Preservation Department – Item 1, LPC-22-08731

**6301 12th Avenue, aka 6301-6323 12th Avenue, 1202-1216 63rd
Street, and 1201-1215 64th Street – Angel Guardian Home –
Individual Landmark
Borough of Brooklyn**

LPC-22-08731: 6301 12th Avenue, Angel Guardian Home - Individual Landmark

PUBLIC MEETING SCOPE 09/20/2022

**64TH STREET
PROPOSED ELEVATION**

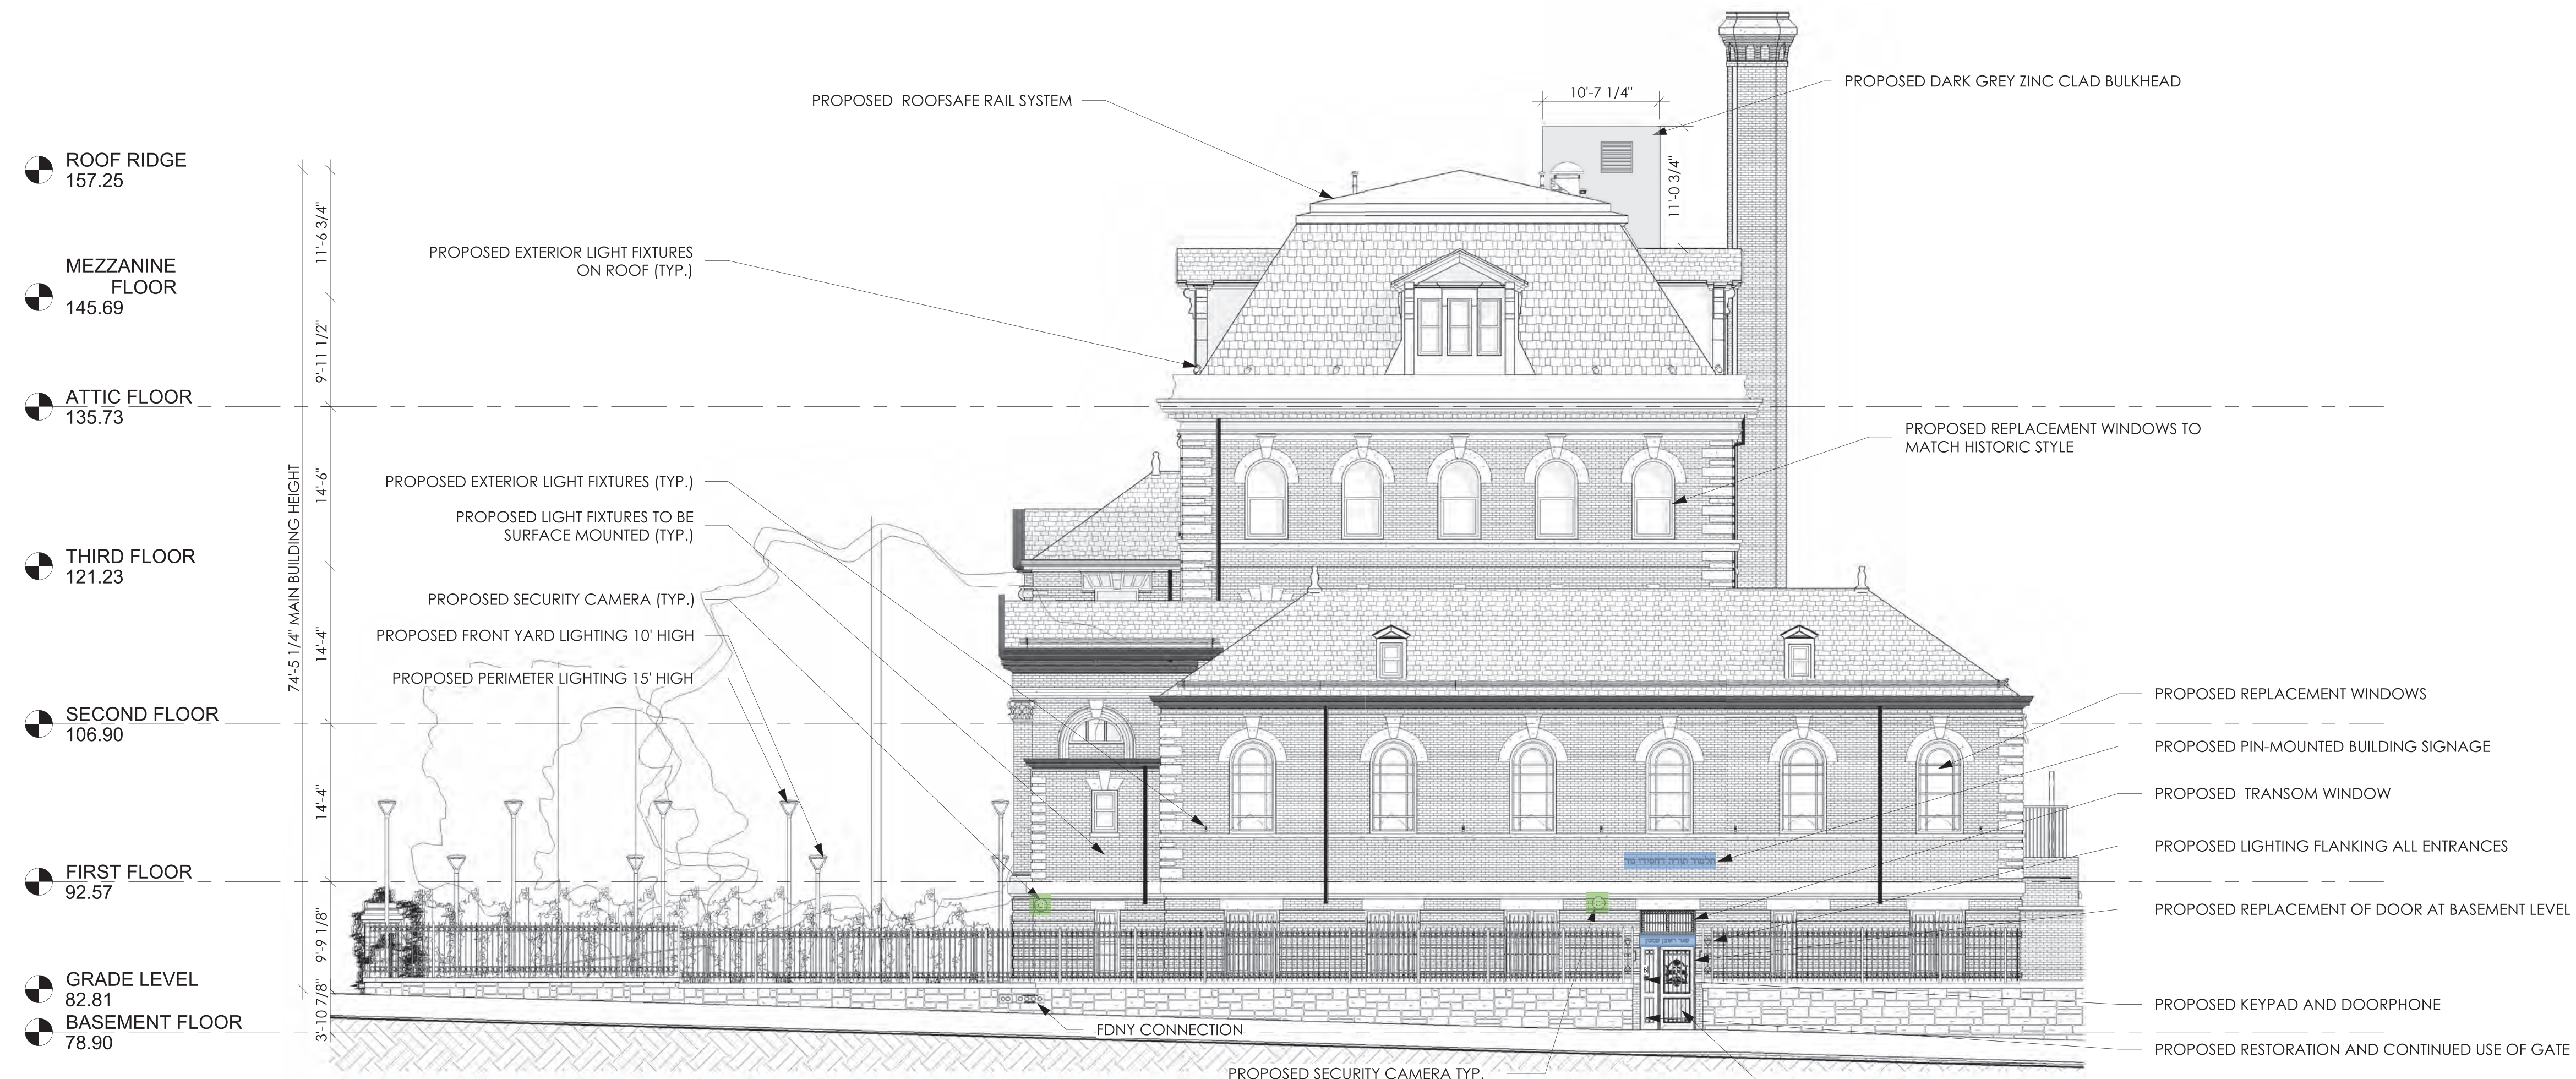
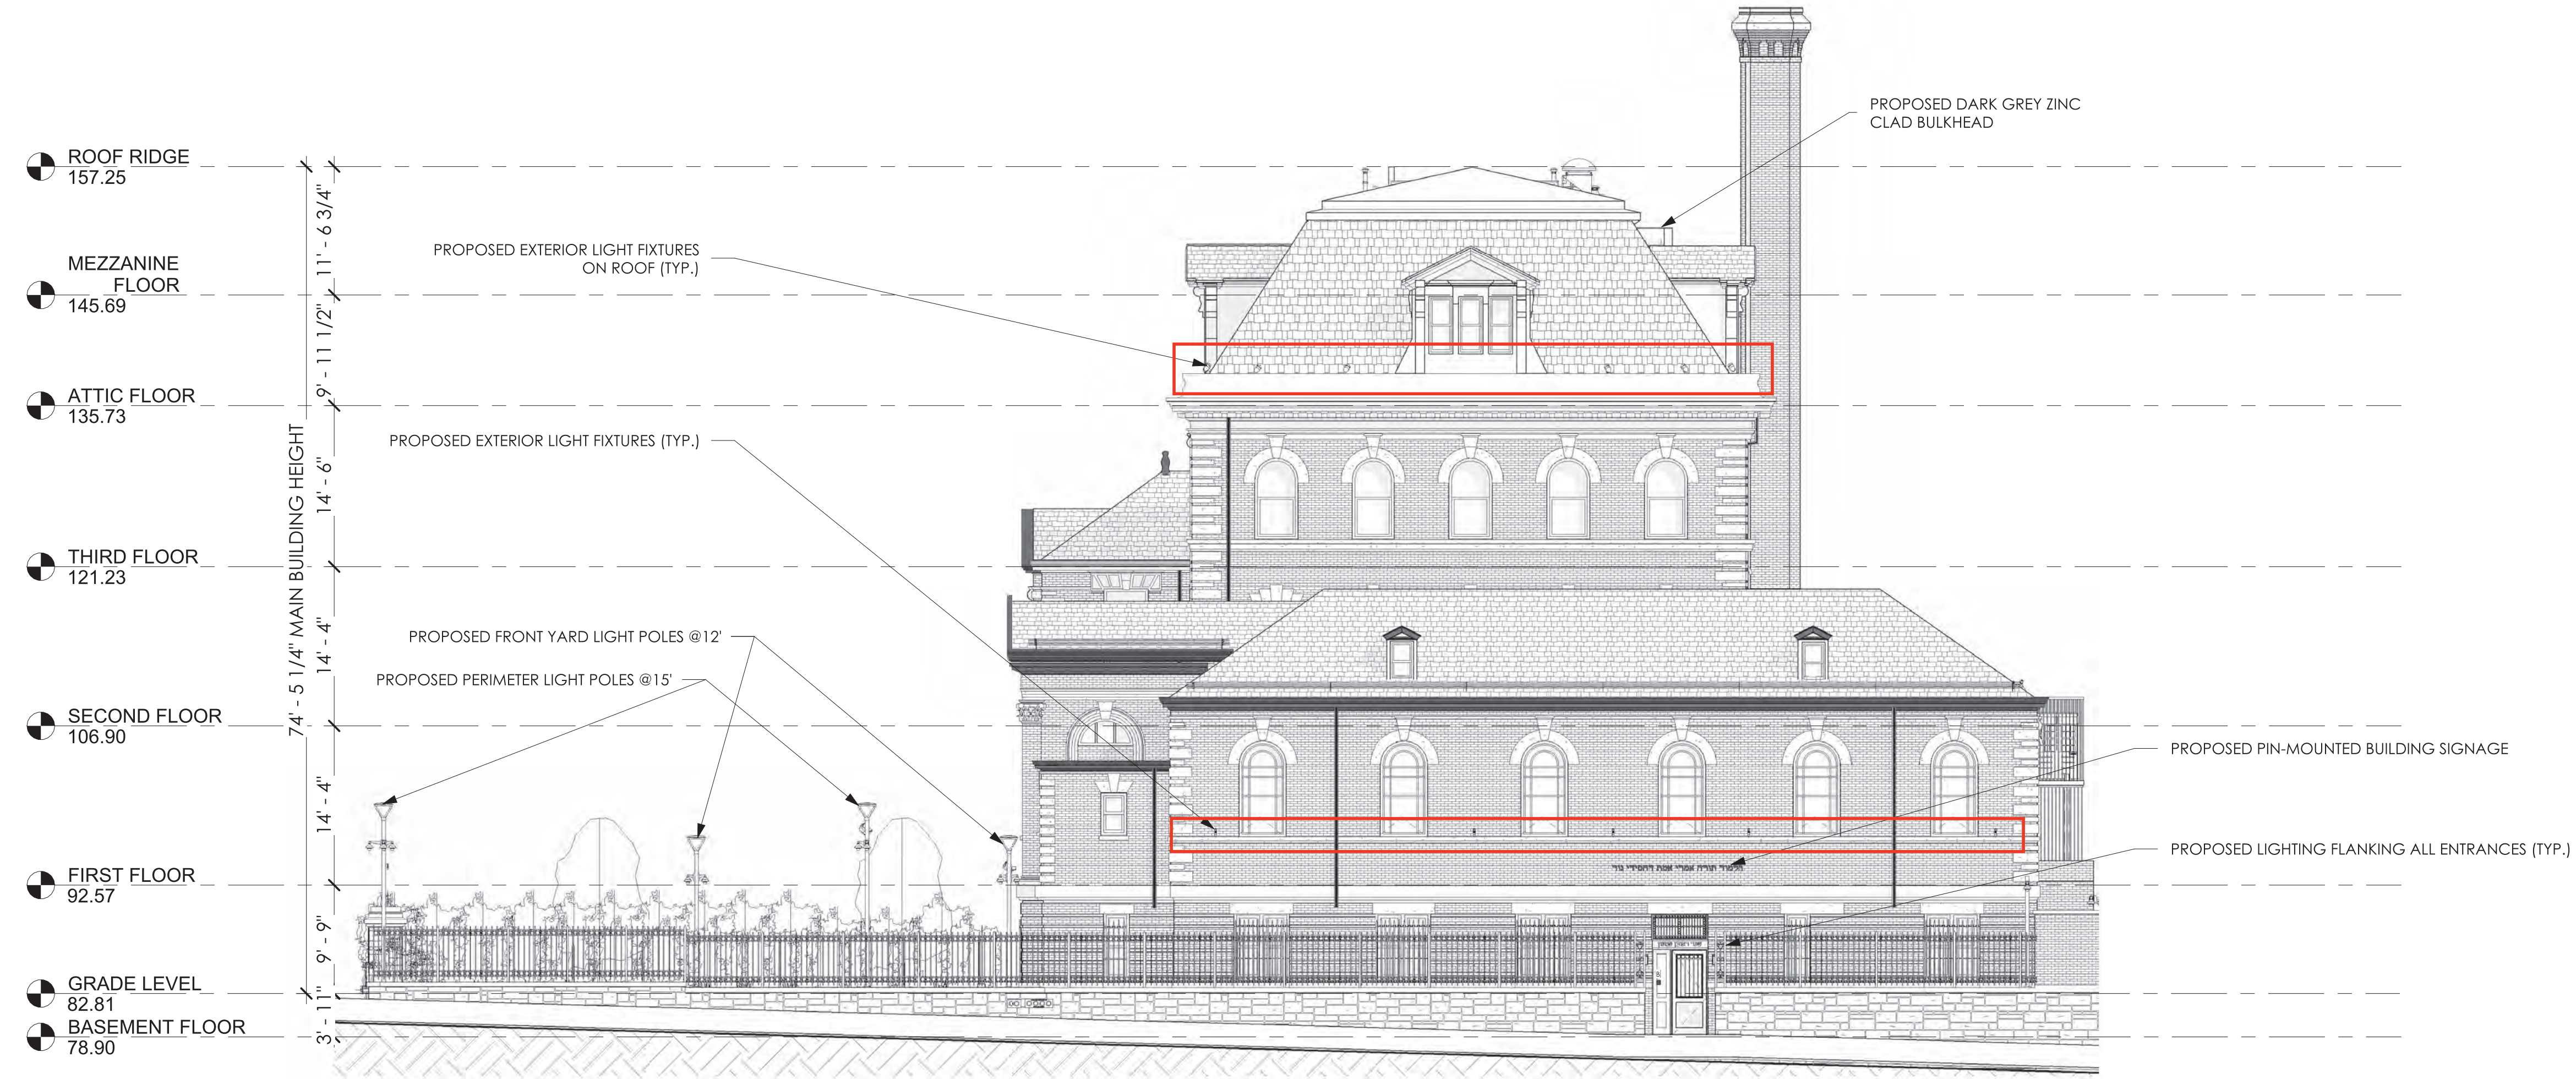
- CHANGES:**
- DOORS REVISED TO MATCH HISTORIC IMAGES
 - SECURITY CAMERA FIXTURES REMOVED
 - LIGHTING, SPEAKER, AND SECURITY CAMERA FIXTURES MOUNTED ON LIGHT POLES
 - REVISED LIGHT POLE PLACEMENT
 - ELEVATOR BULKHEAD LOWERED
 - MECHANICAL DUNNAGE WIDENED

**REAR FACADE
PROPOSED ELEVATION**

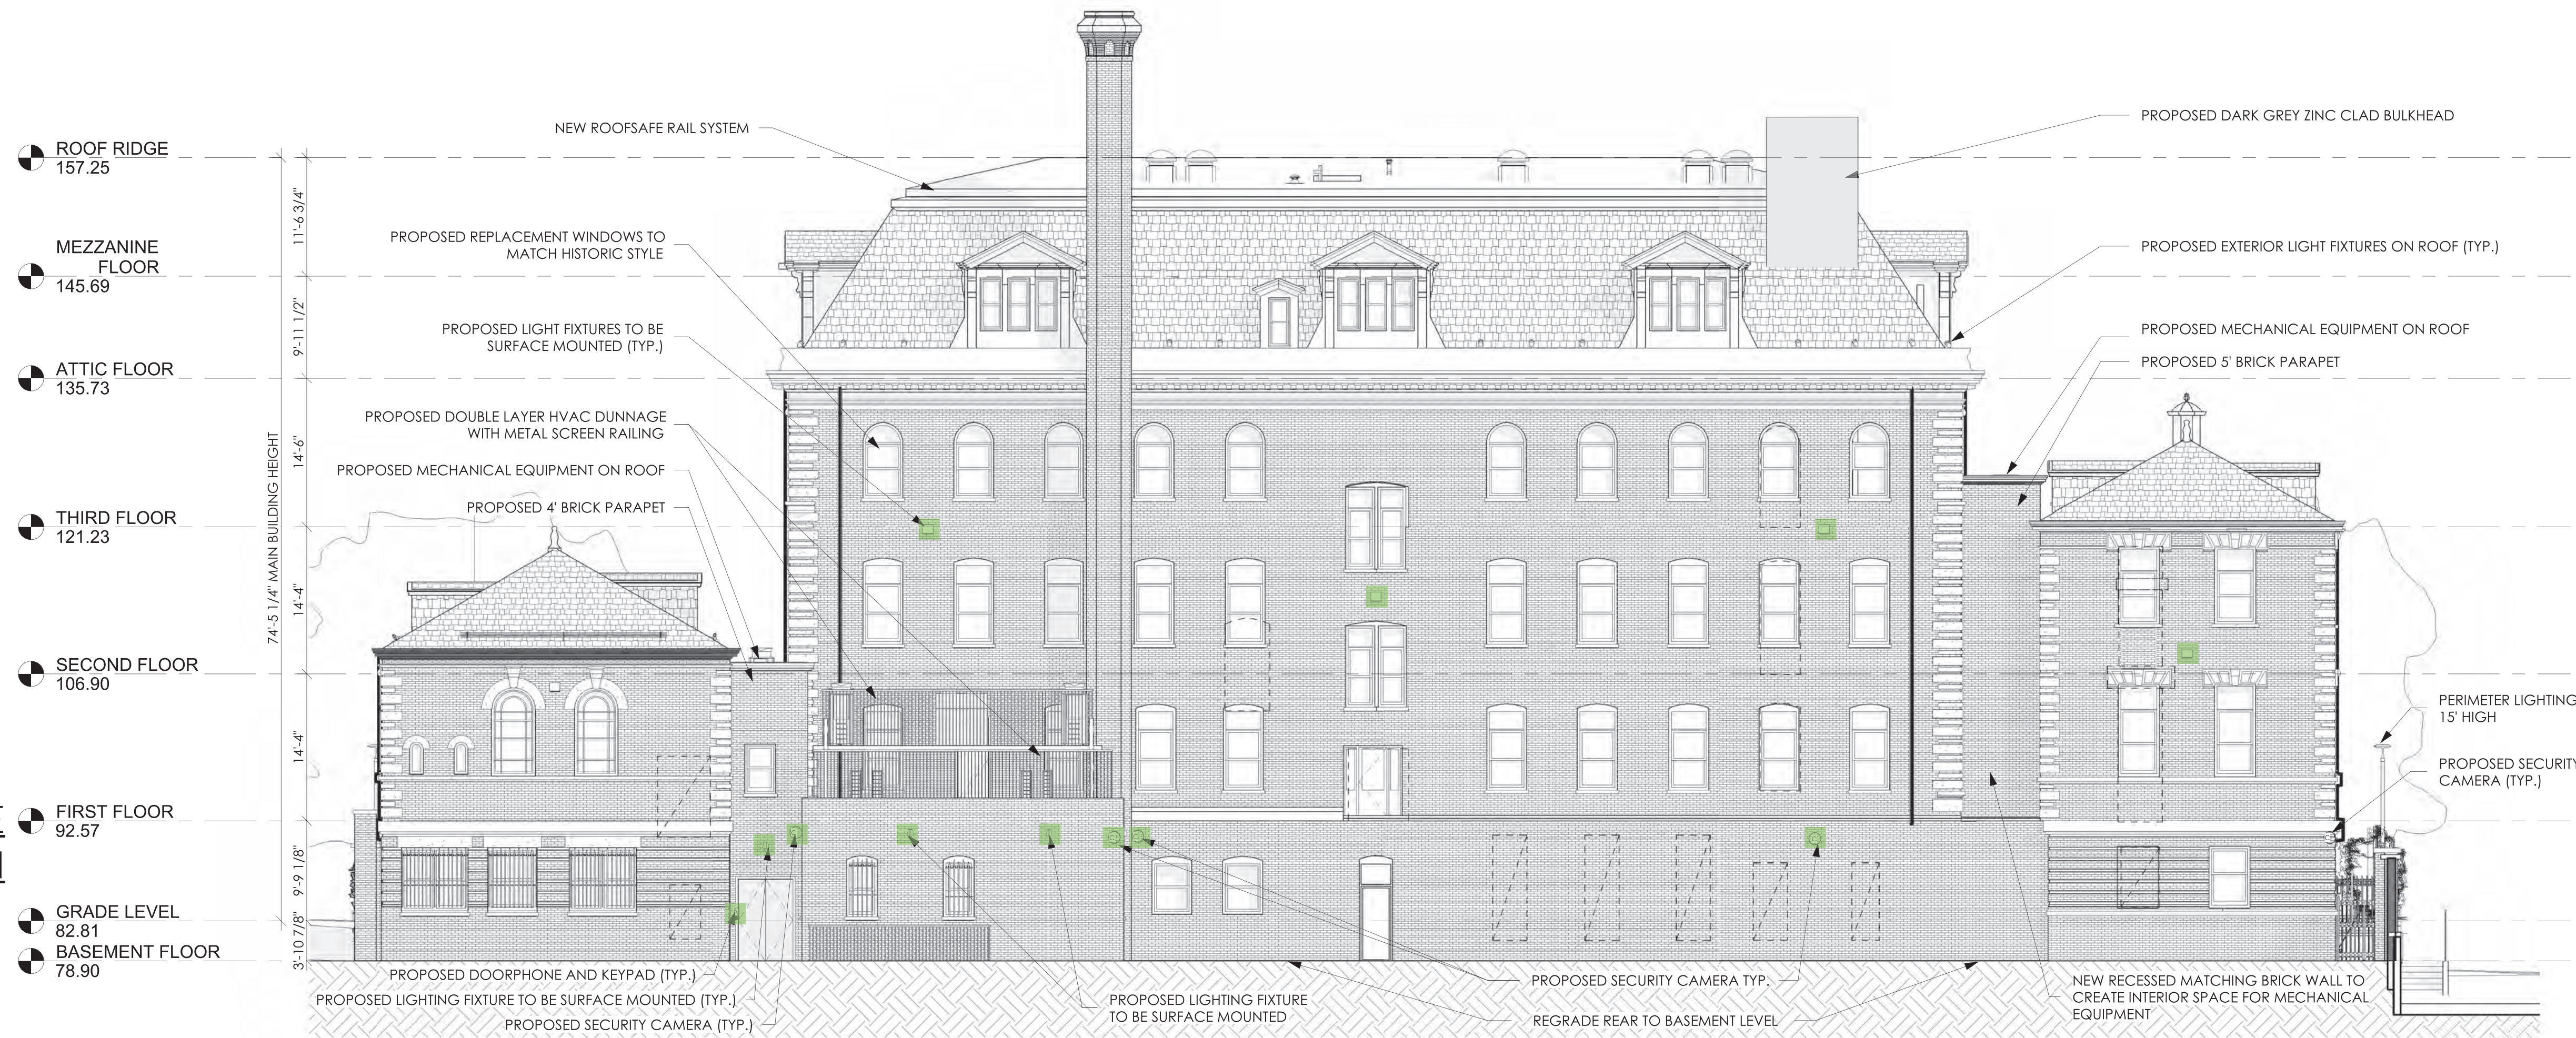
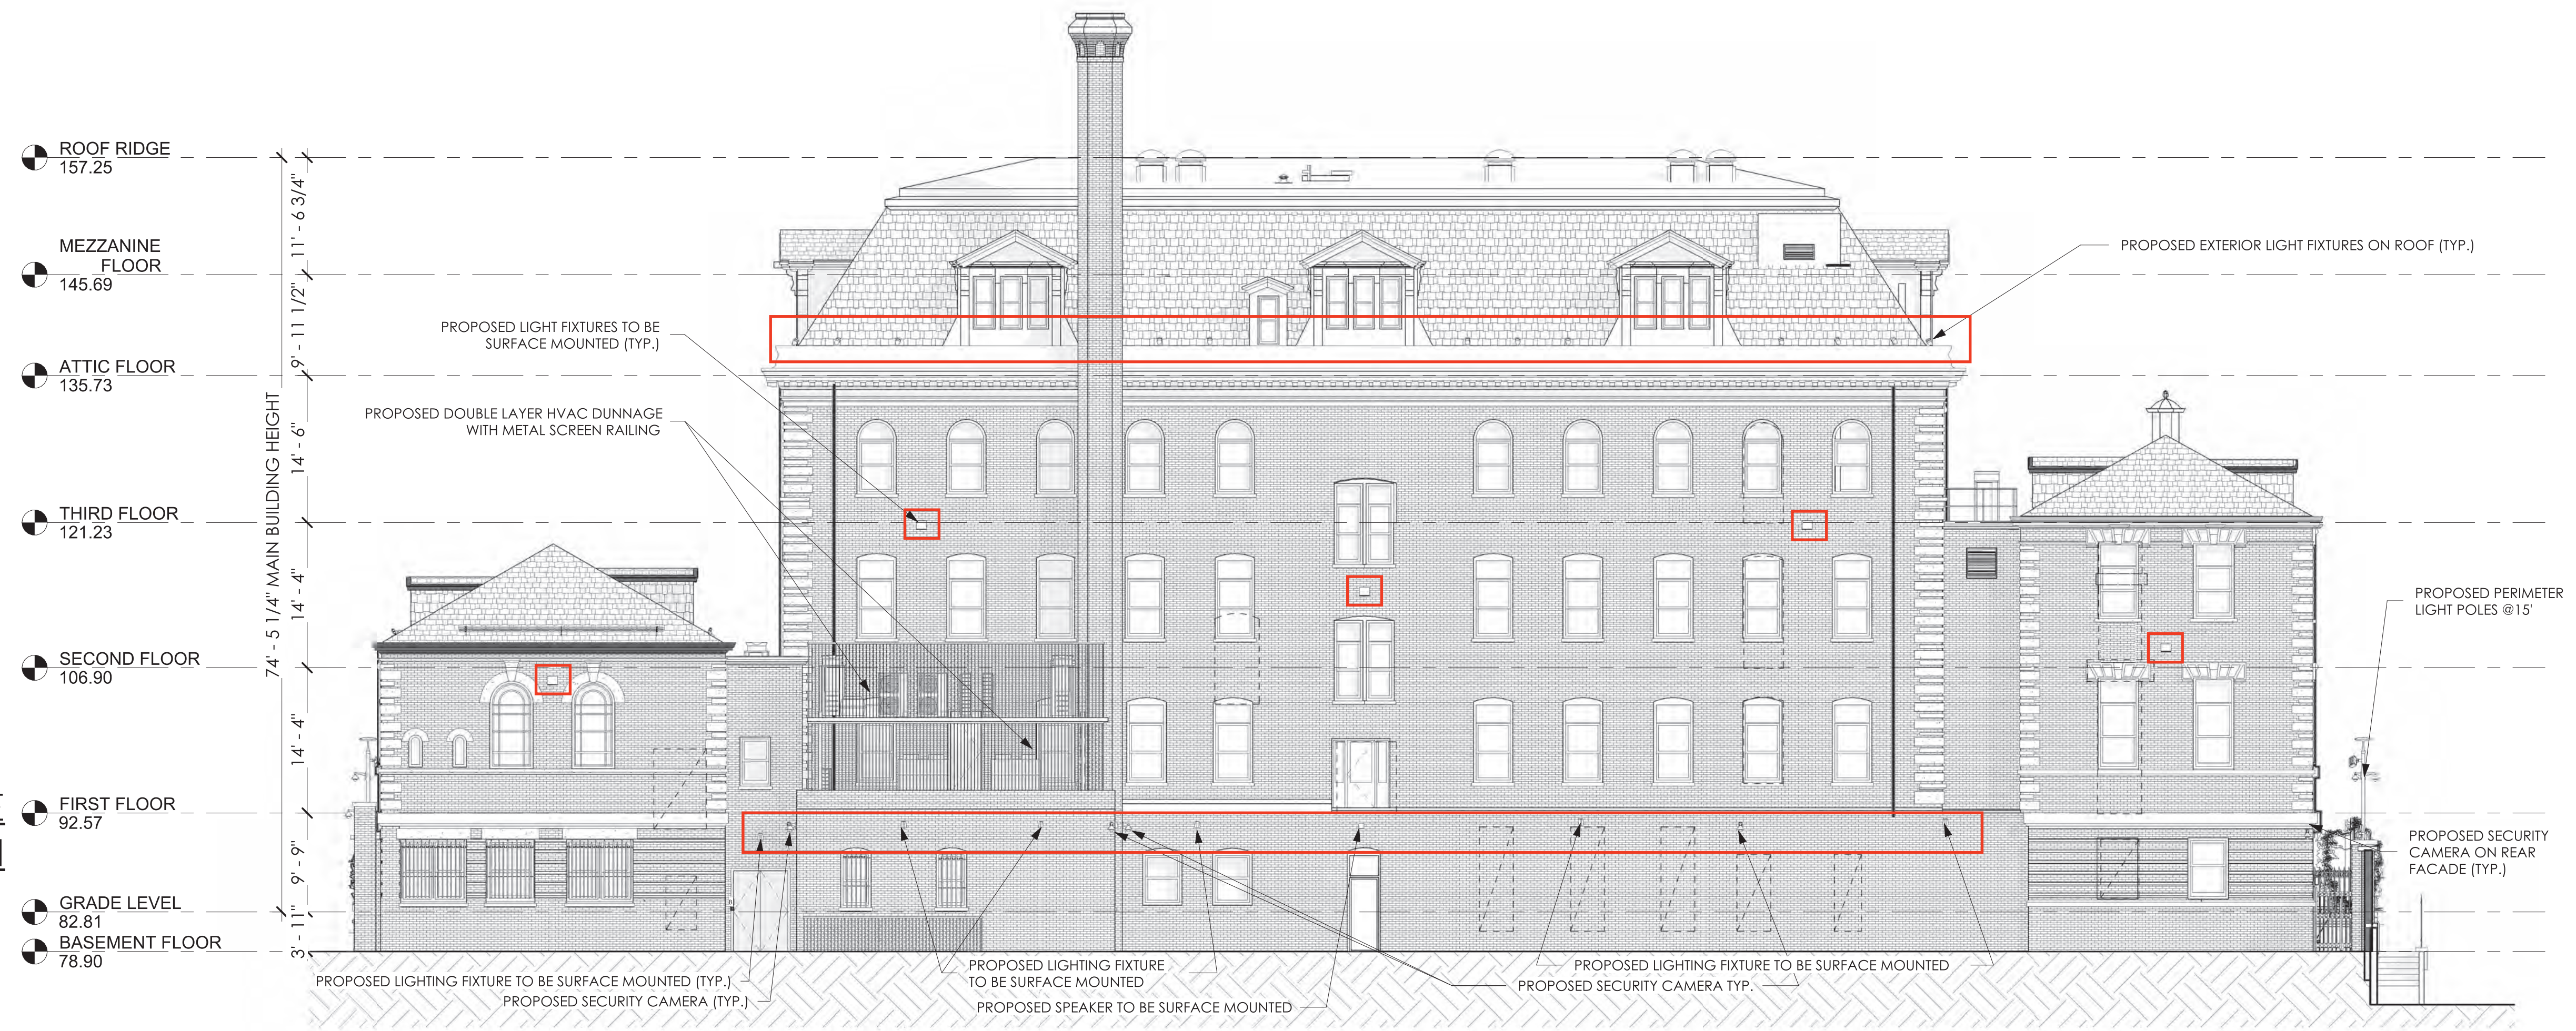
- CHANGES:**
- ELEVATOR BULKHEAD HEIGHT
 - DOWNSPOUTS MATCH COPPER
 - ADDITIONAL REAR FACADE LIGHT AND SECURITY CAMERA FIXTURES
 - NEW MECHANICAL LOUVRE
 - MECHANICAL DUNNAGE WIDENED
